Planning and Zoning Board Agenda January 10, 2017

SUBJECT: Site Plan: Holiday Inn, Alachua: A request by Sergio Reyes, P.E., of eda, inc., applicant and agent for Hipp Investments, LLC, property owners for consideration of a Site Plan for the construction of a ±58,821 sf (92 room) hotel on a ±4.24 acre subject property. Tax Parcel Number 03053-001-001 (Quasi-Judicial Hearing).

Planning & Community Development Department Staff Report

SUBJECT: A request for a Site Plan for the construction of a $\pm 58,821$ sf (92 room) hotel with employee and visitor parking, storm water management facility improvements, paving, grading, and associated utility infrastructure

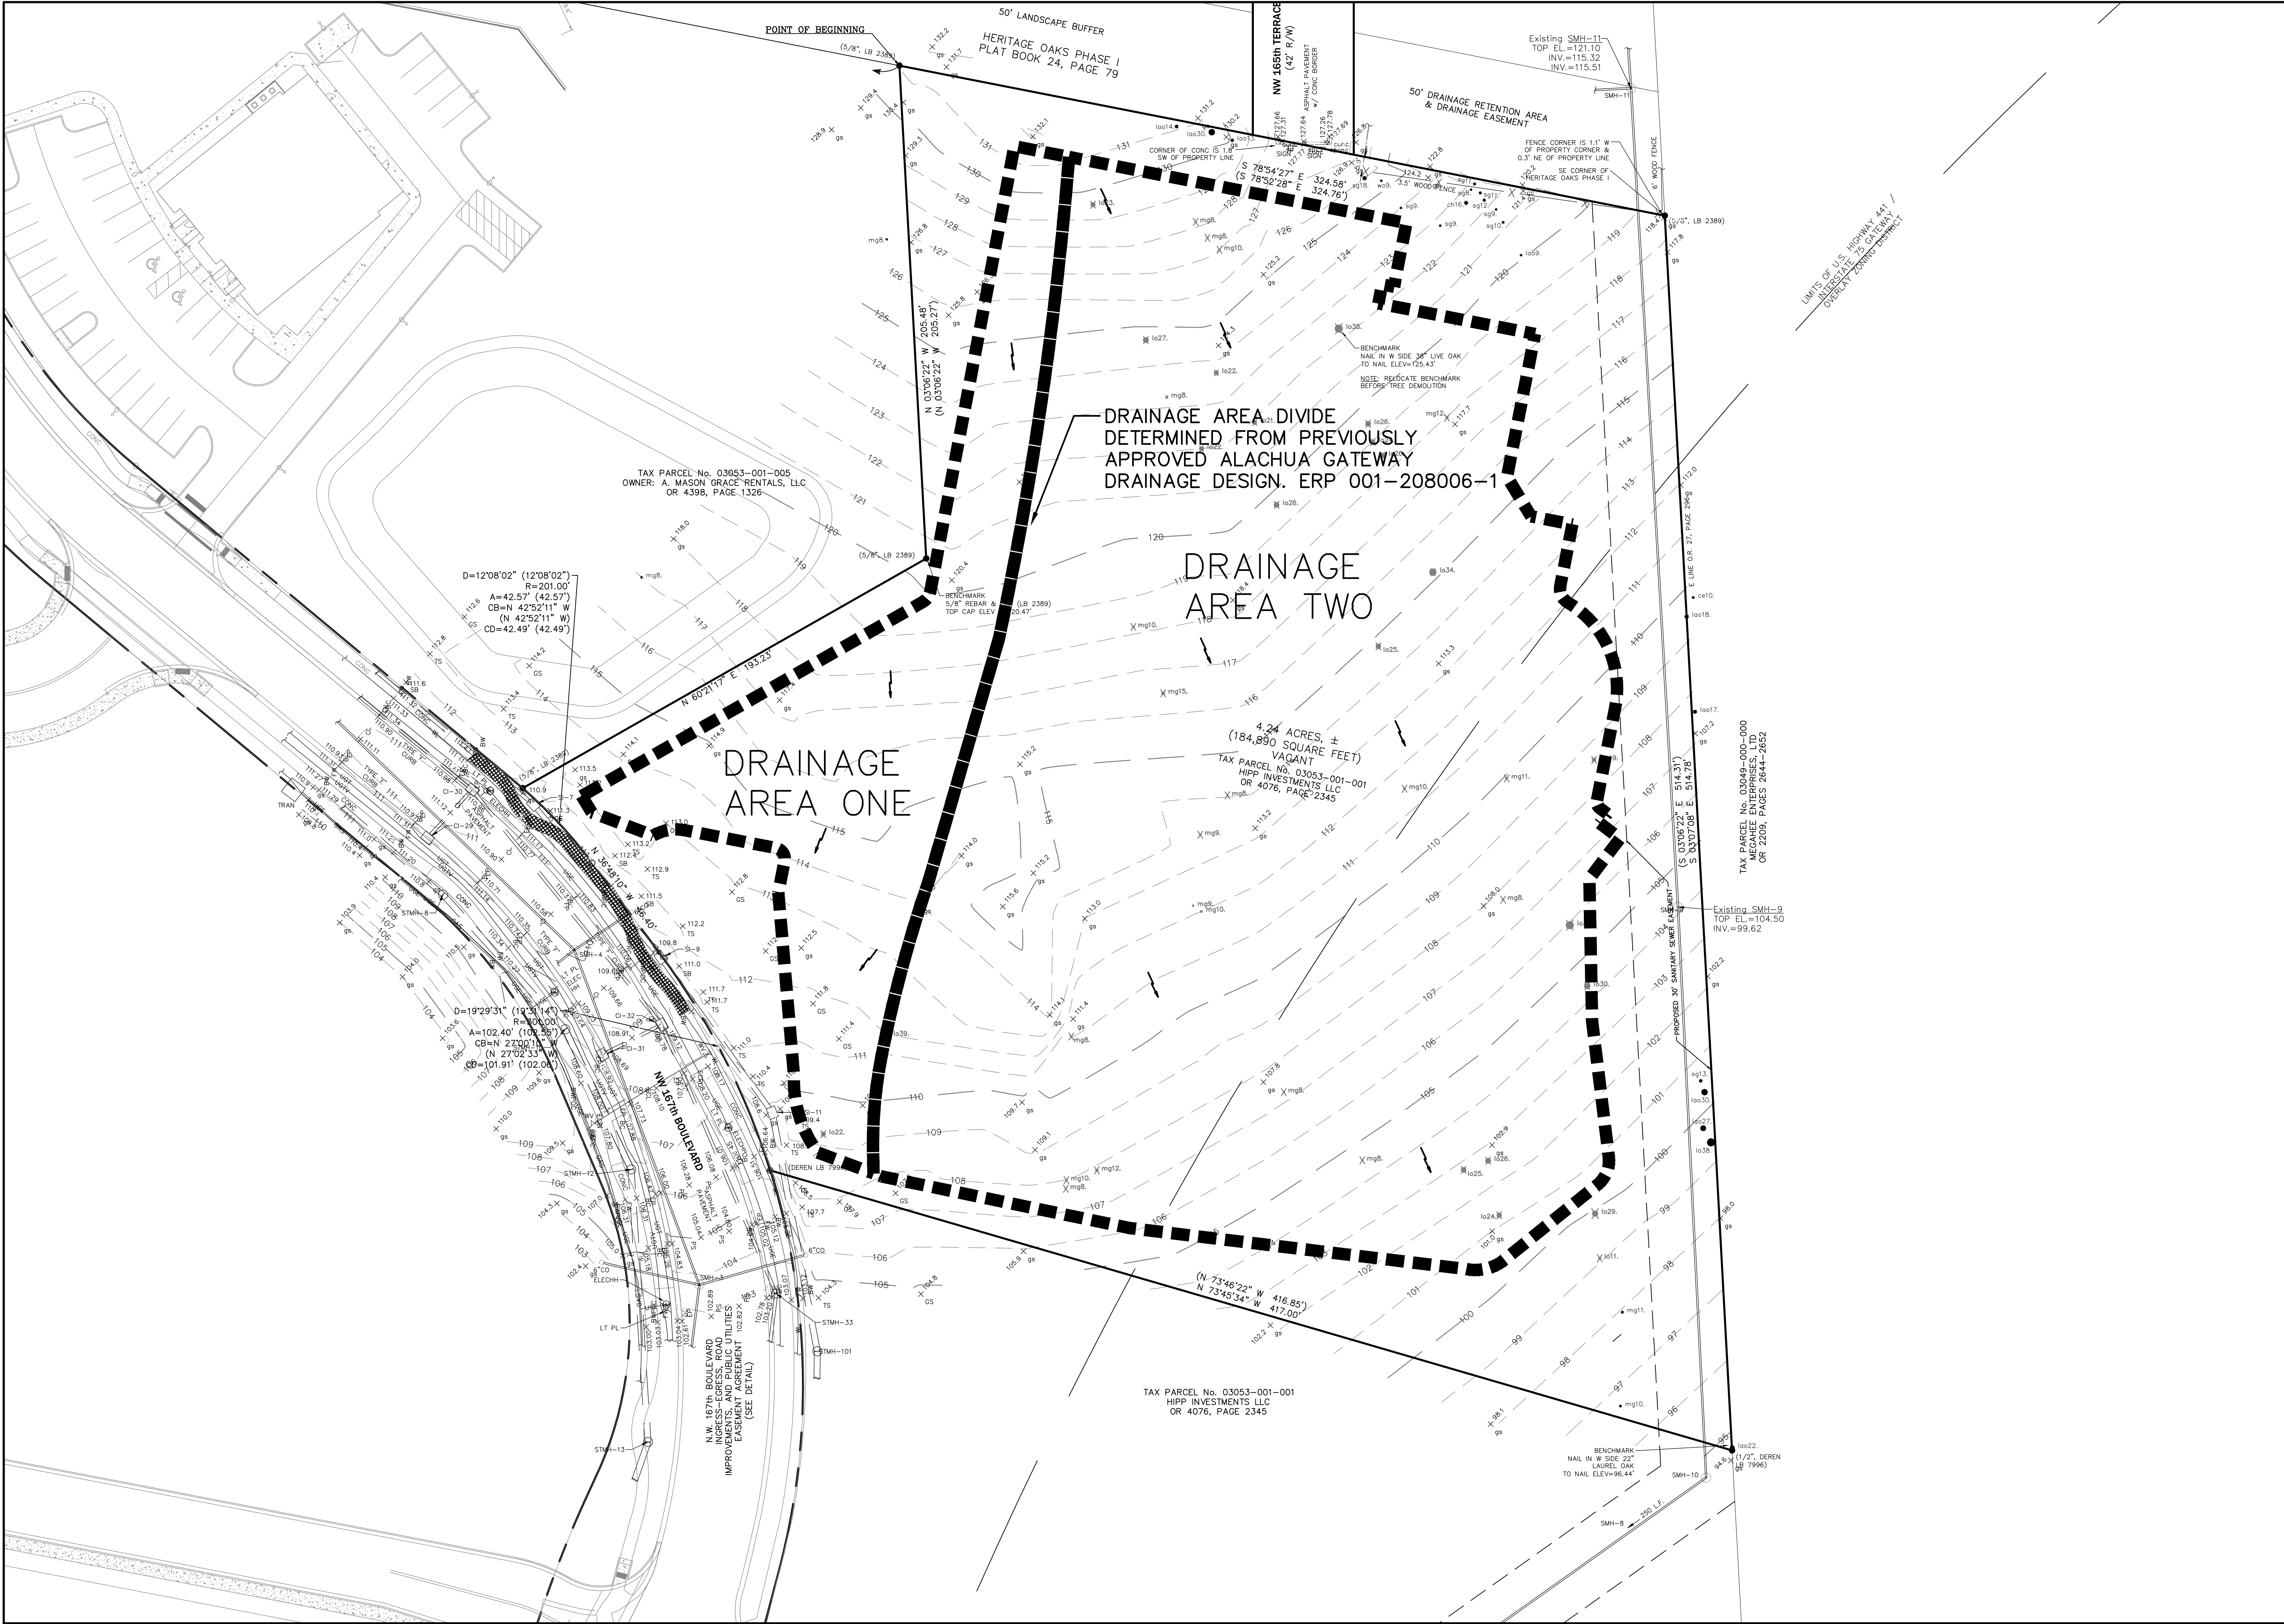
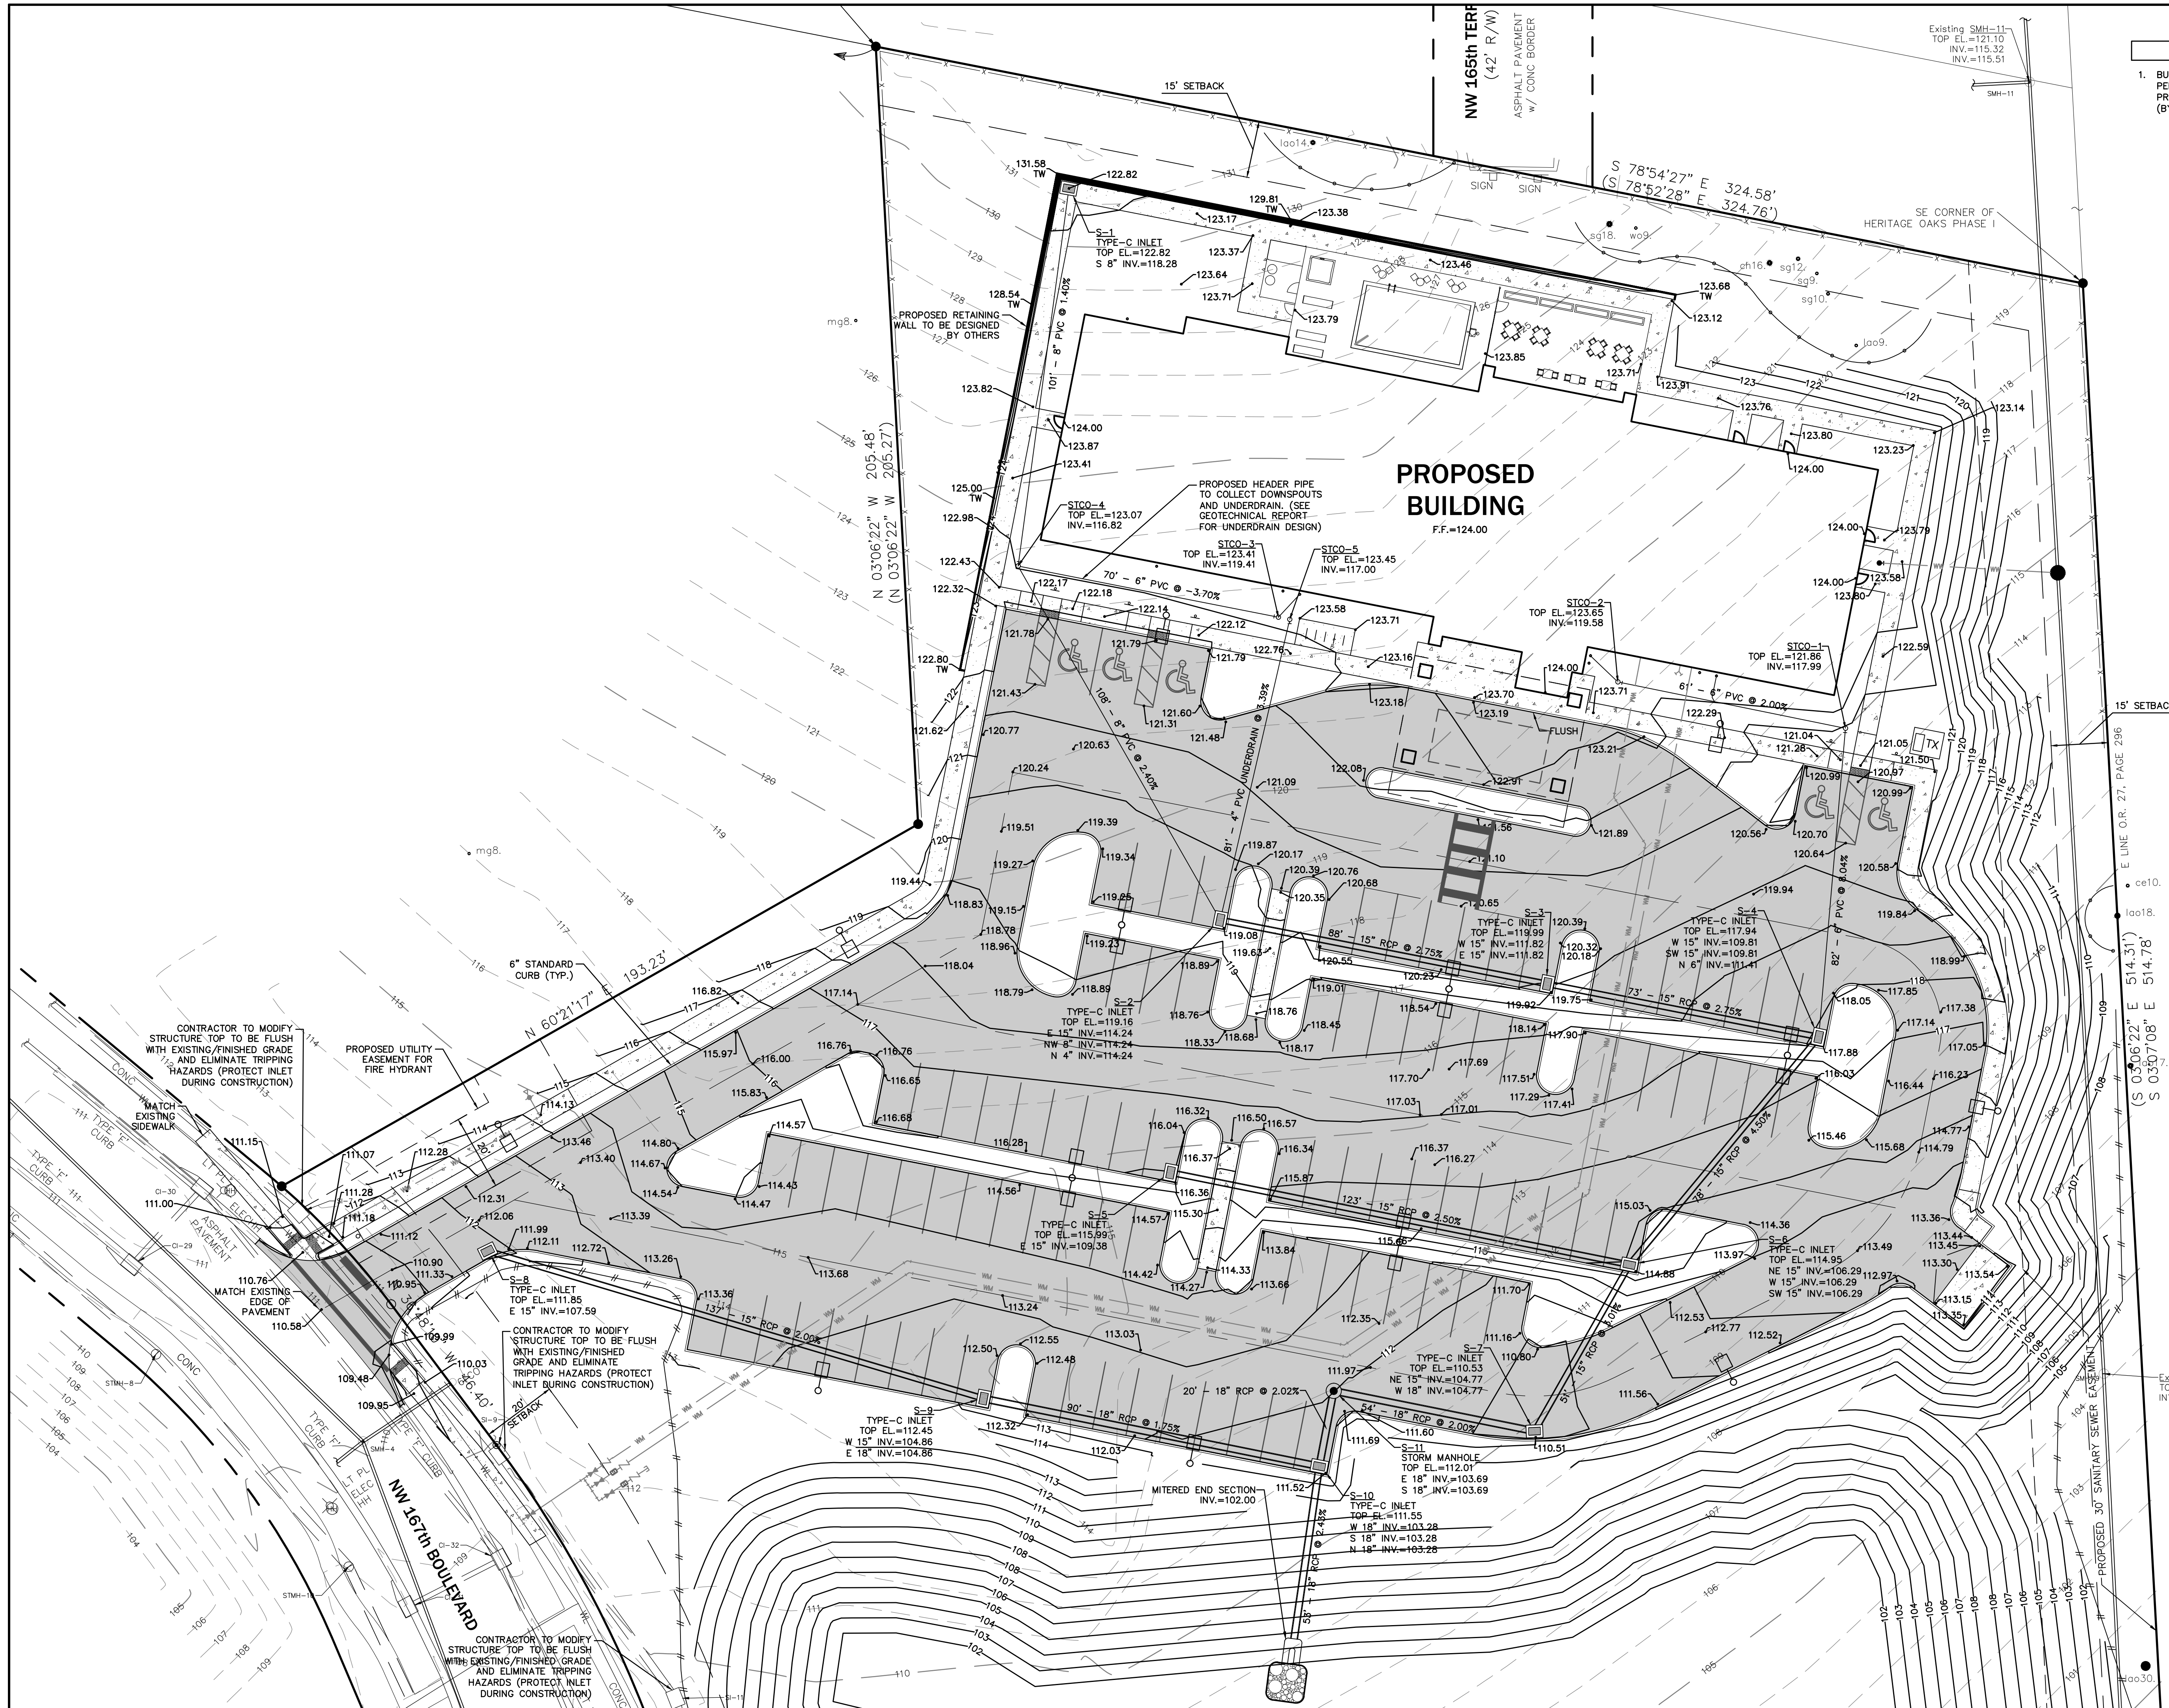
2.	<u>Existing Drainage Structures</u> ; Sheet C2.00 Contractor to modify structure top to be flush with existing finished grade <u>AND</u> eliminate tripping hazard(s). Typical existing structure of 2. [Approved as Noted]

2.	Existing Drainage Structures: Sheet C2.00 Contractor to modify structure top to be flush with existing/finished grade AND eliminate trapping hazard(s). Typical existing structure of 2. [Approved as Noted]

Response: See sheet C2.00 of the revised plan set. Curb and gutter transition detail is specified on sheet C2.00.

Response: See revised sheet C2.00 for additional spot elevations.

Response: See revised sheet C2.00 for additional spot elevations. Grades were checked and annotated on sheet C2.00.
